FAIRFAX ACQUISITIONS LTD

LAND ADJOINING ANSTY

TRANSPORT ADDENDUM

REPORT REF.
2207280-R28A

3.3. **Figure 2.1** shows the existing PRoWs through and surrounding the site, and **Figure 2.2** shows the indicative upgraded PRoW network. **ACE Drawing 2207280-D014A** provides the proposed upgraded PRoW network in full context of the emerging development masterplan.

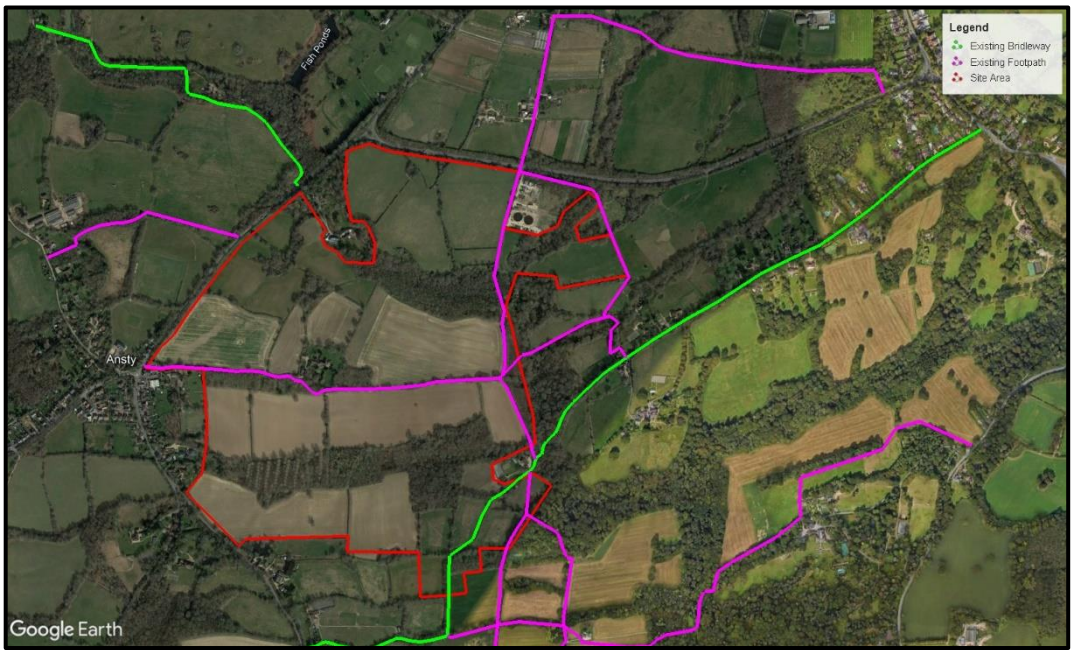
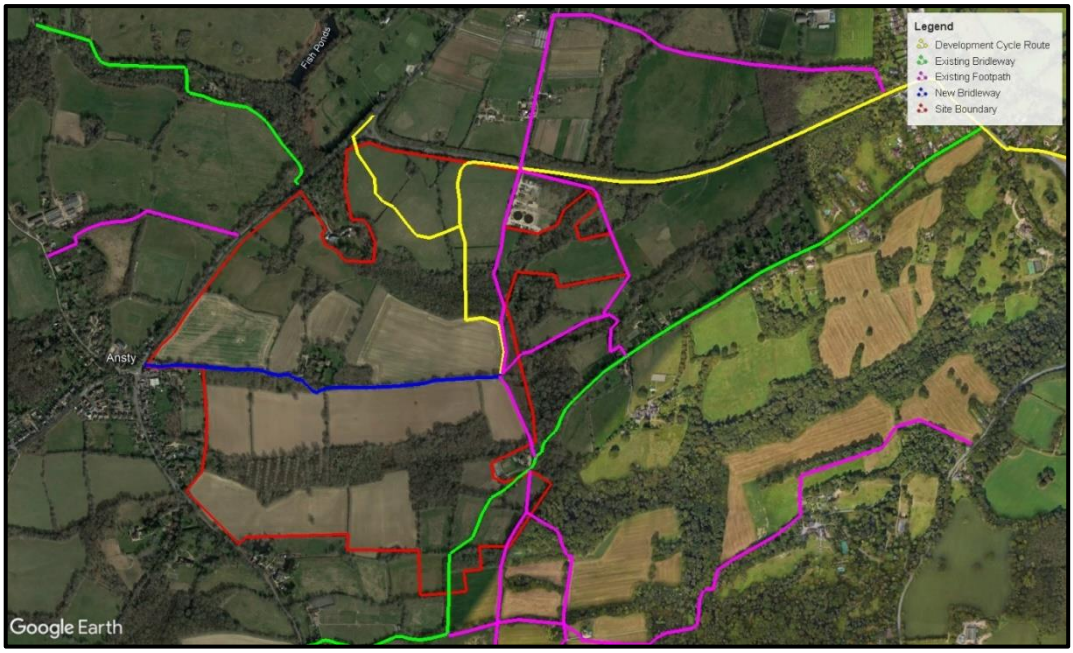
"The planning Statement and Travel Plan State an intention to upgrade all PROW to bridleways which would allow for pedestrian, cycle and equestrian use. It isn't realistic to upgrade all PRoWs and I am objecting on this basis."

Drawing Number: 2207280-005 — Rev: D

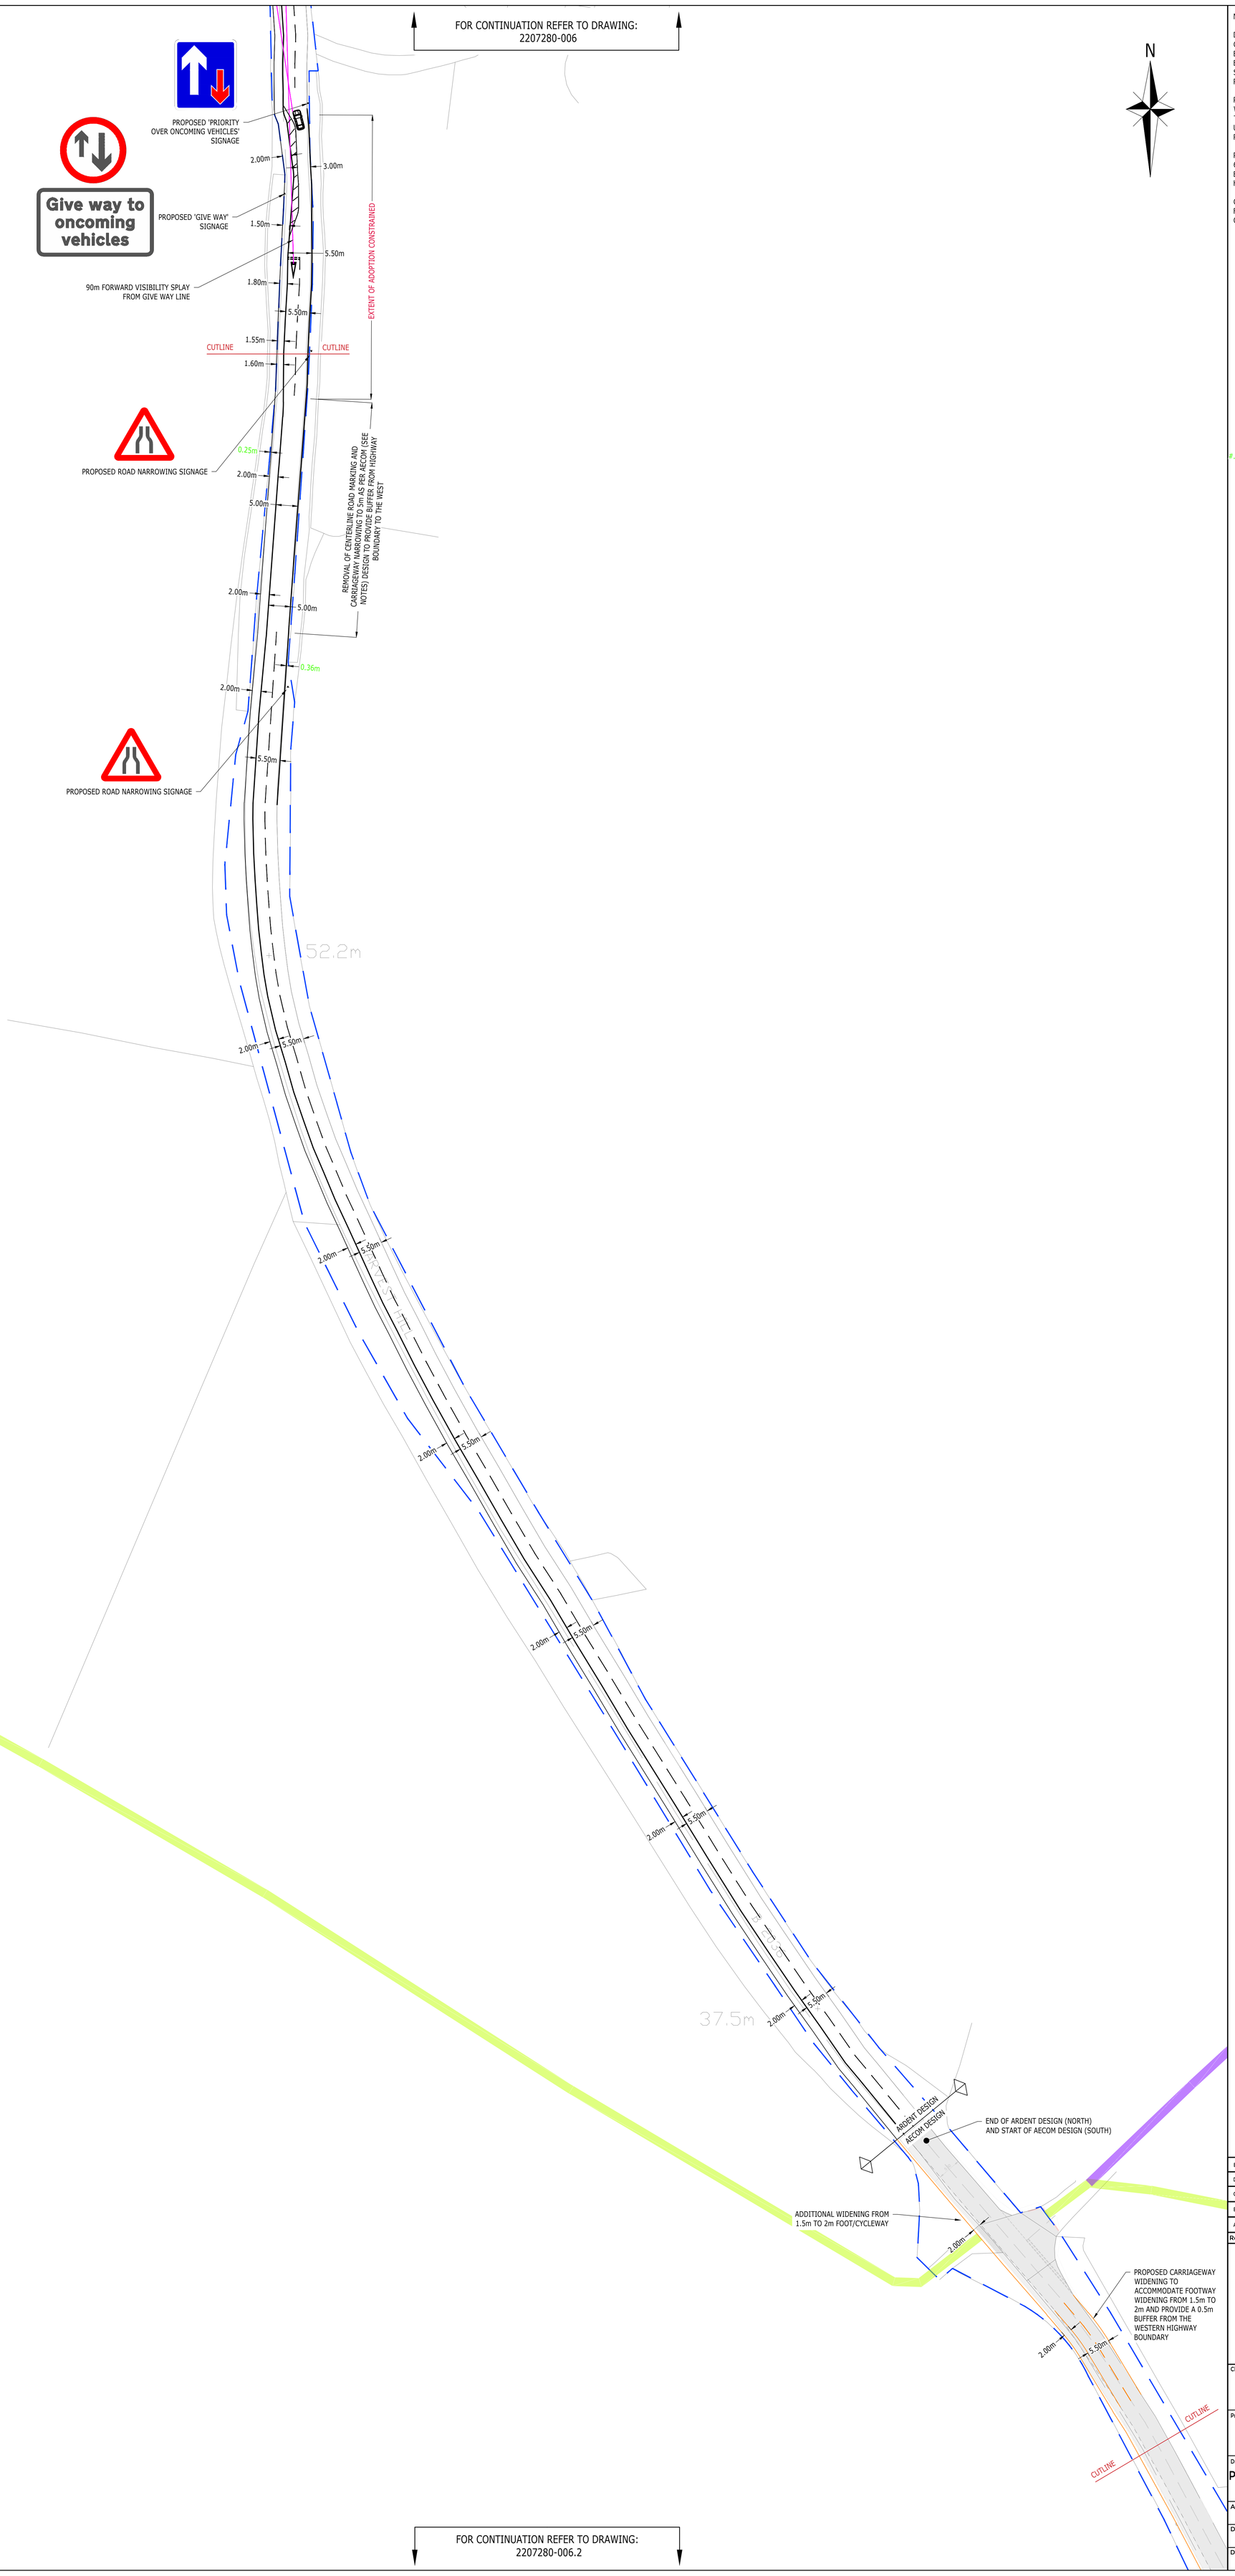
Consultation Response - *"The southwestern access would require cyclists to rejoin the carriageway in close proximity to the roundabout and continue on road along the B2036 towards the Brookleigh development and Burgess Hill. Given the flows and speeds of the road then the promotion of on road cycling would not be in keeping with the requirements of LTN 1/20."*

2.97. **ACE Drawing 2207280-005D** shows a connection between the proposed southern access roundabout and the existing footway on the east side of the B2036 Harvest Hill into Ansty.
